Our ref: DOC25/337782
Your ref: SSD-10269-Mod-1

Narrabri Underground Mine Stage 3 – Modification 1

CPHR's comments and recommendations

Figure 2: Comparison of modification report figure (left) and project design approved by DPHI in March 2025 (Right). Areas in pink have been removed from the project design.

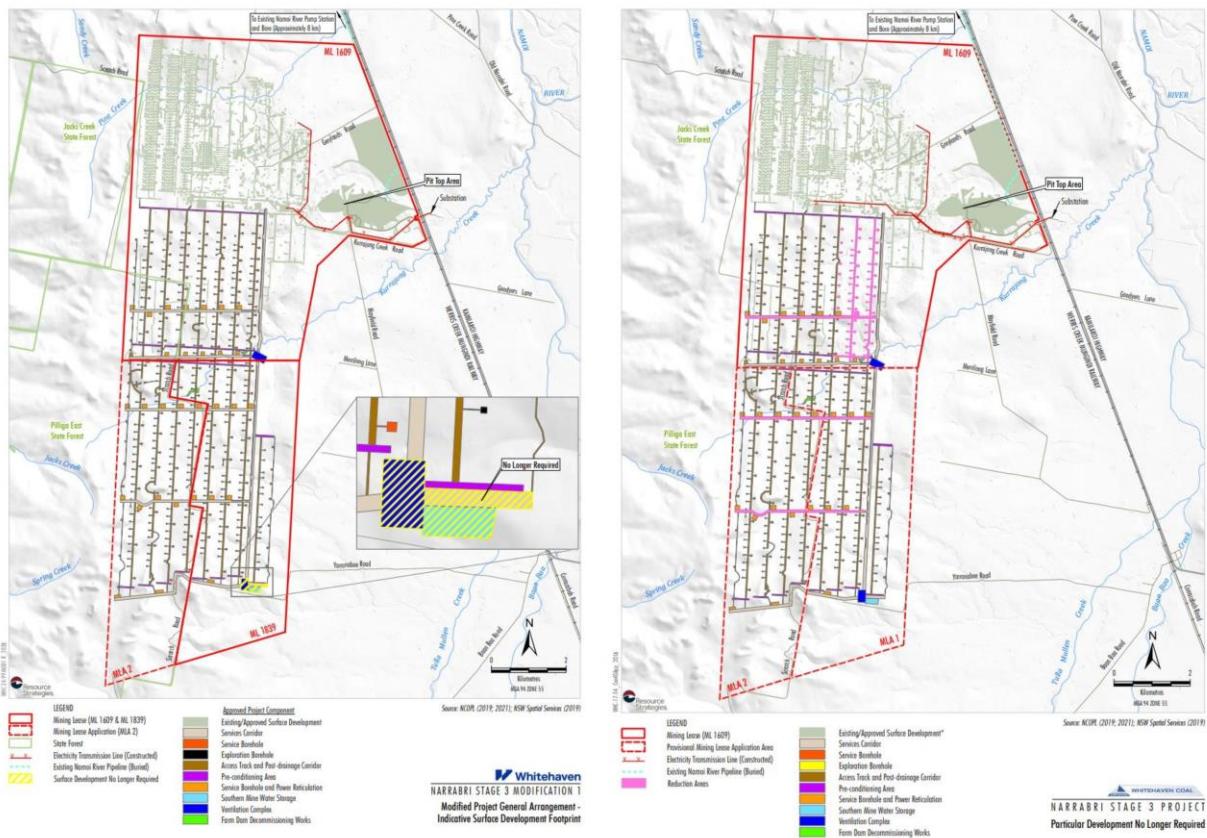
The modification document references an approval provided by DPHI in March 2025 to reduce the project's impacts by removing several development components e.g. access tracks, boreholes, etc. However, the figures in the submitted modification report still include these as approved project components (See Figure 2).

It is important that the modification report and Appendix 2 of the Stage 3 consent accurately reflects the modified project design, so that impacts and the associated credit obligation can be tracked through time.

- 1.1 Revise Figure 2 of the modification report to accurately reflect the approved reduced project design. This revision should also be updated in Appendix 2 of the Stage 3 consent, if MOD 1 is approved.
